## CITY OF UNALASKA

### ADDENDUM 01

**SUBJECT: INVITATION TO BID  
UNALASKA PYRAMID WATER TREATMENT PLANT – LT2 UPGRADE  
PROJECT NUMBER: DPW # 13401**

# **ATTACHMENT A**

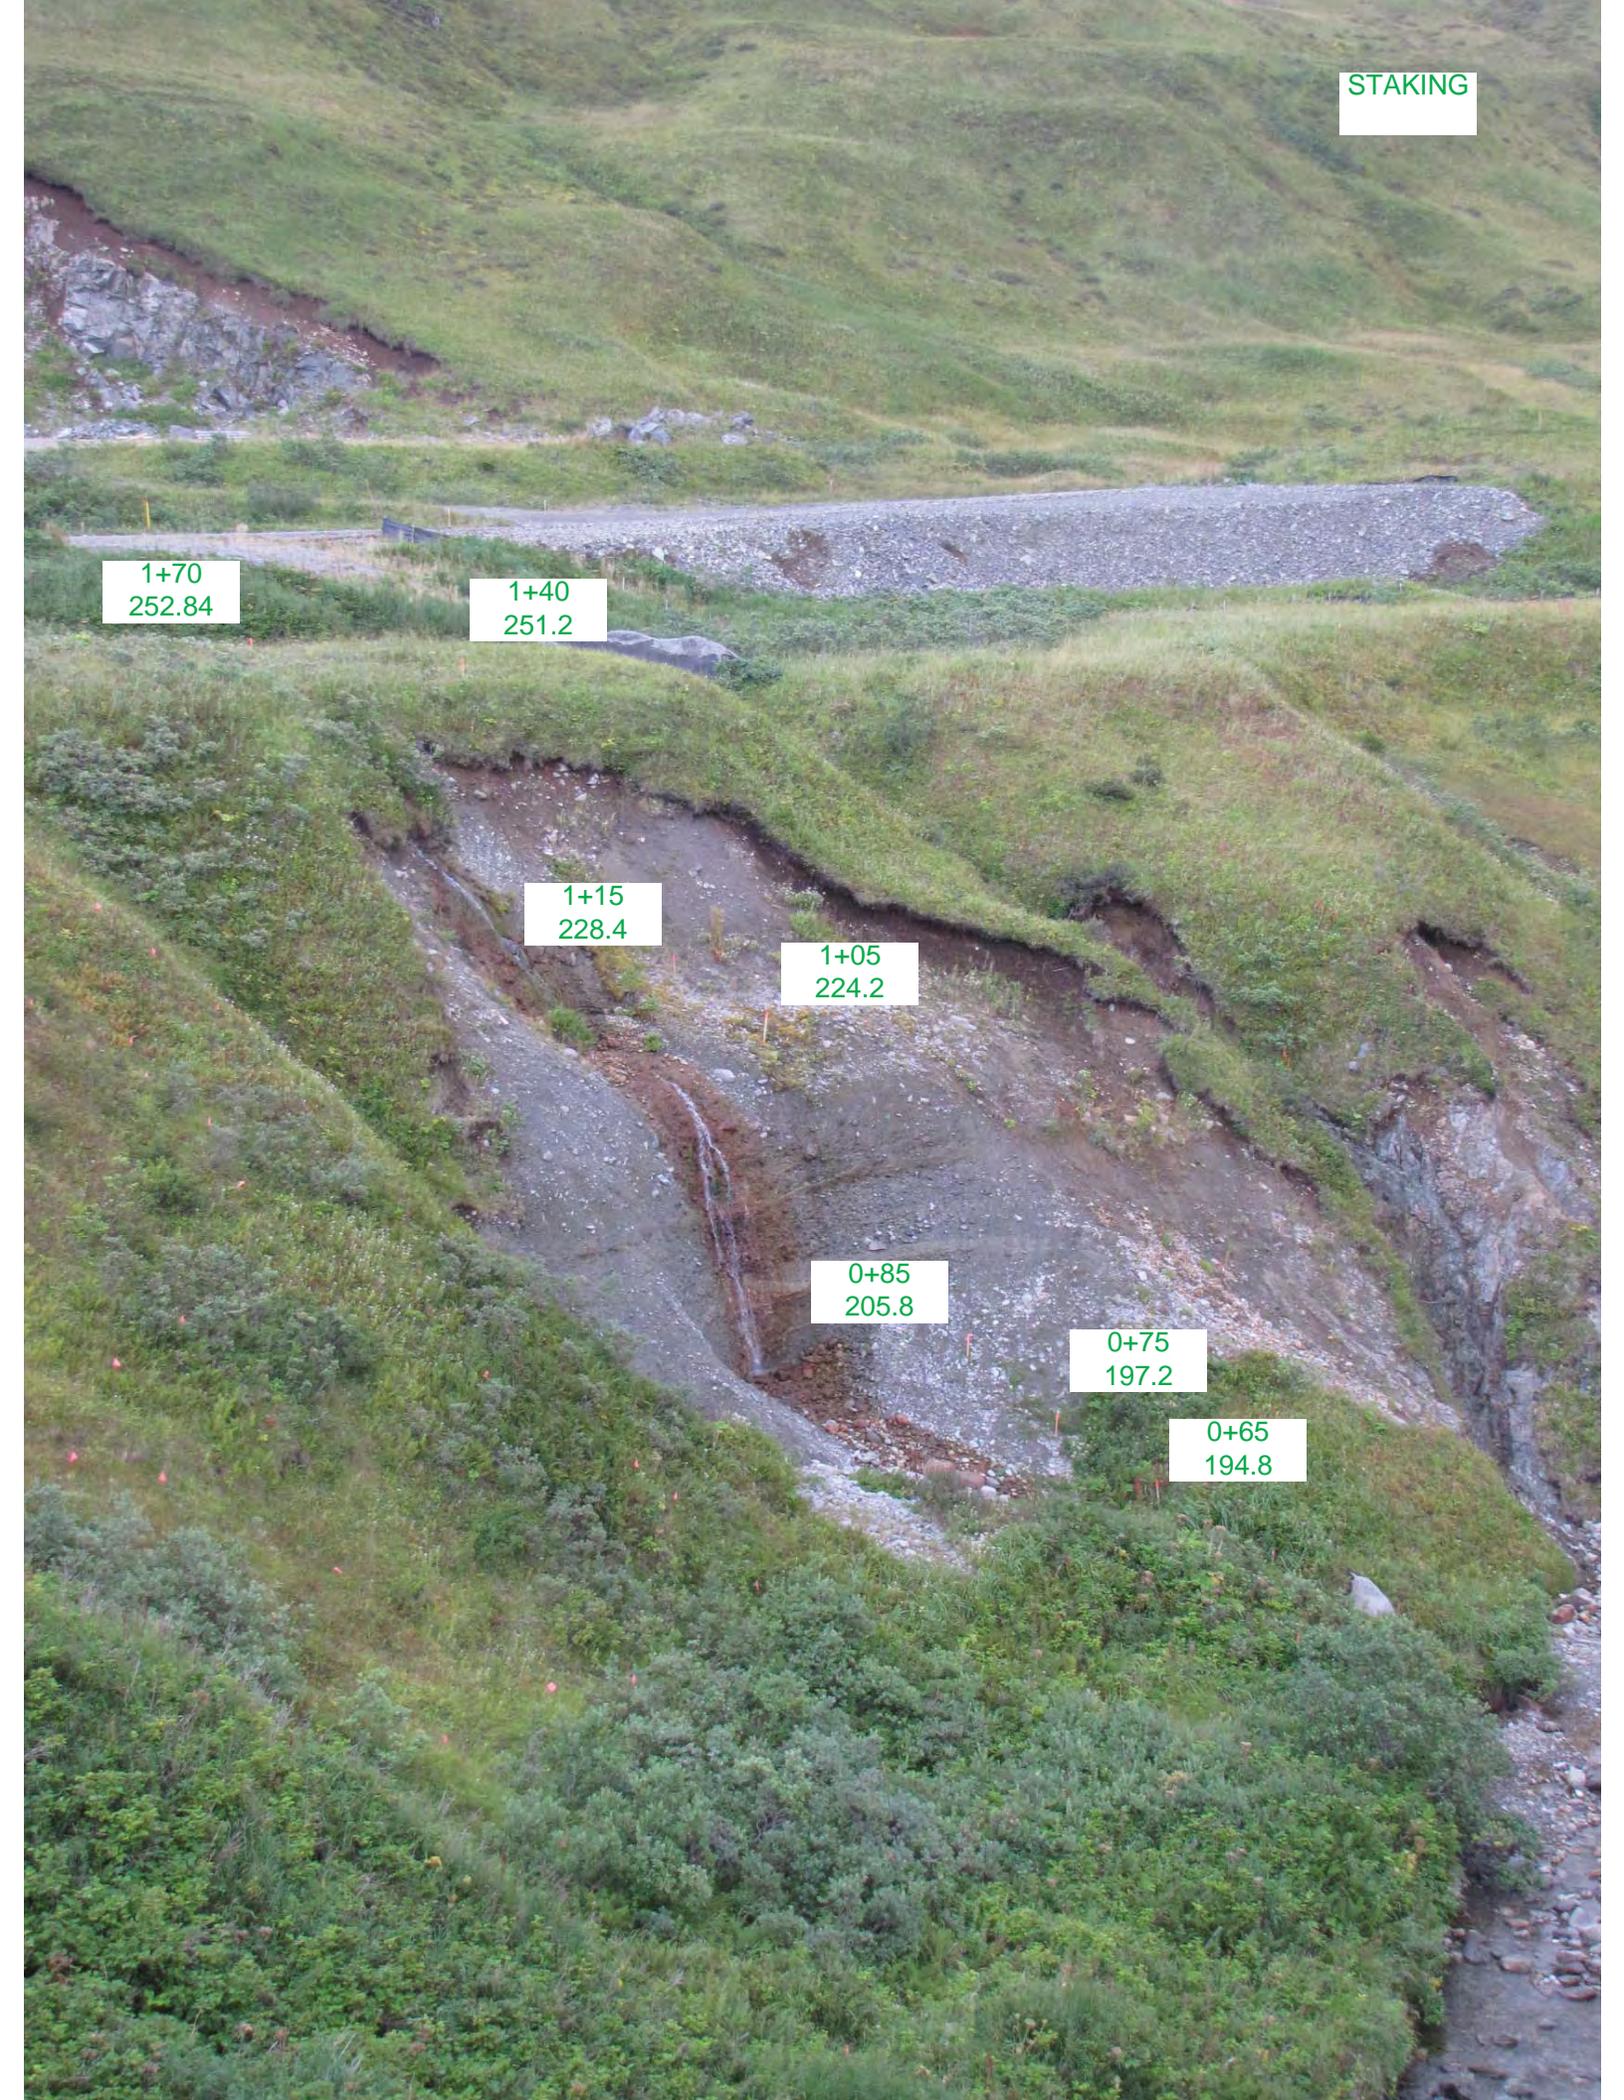
5. Section 00500 2.1, Change "The CONTRACTOR shall have until August 15, 2015 to substantially complete the project. The contractor shall have until September 30, 2015 for final completion." to "The CONTRACTOR shall have until August 1, 2015 to substantially complete the project. The contractor shall have until September 30, 2015 for final completion."
6. Part 7 Geotechnical Reports: Delete "NGE-TFT Field Activities and Foundation Recommendation, October 2013" add "NGE-TFT Field Activities and Foundation Recommendation, November 2013".
7. Part 7 – Geotechnical Reports: Add a 4<sup>th</sup> line with text "Discharge Location Photos".

**Attachment A** of this addendum shall be included in Part – 7 Geotechnical Reports.
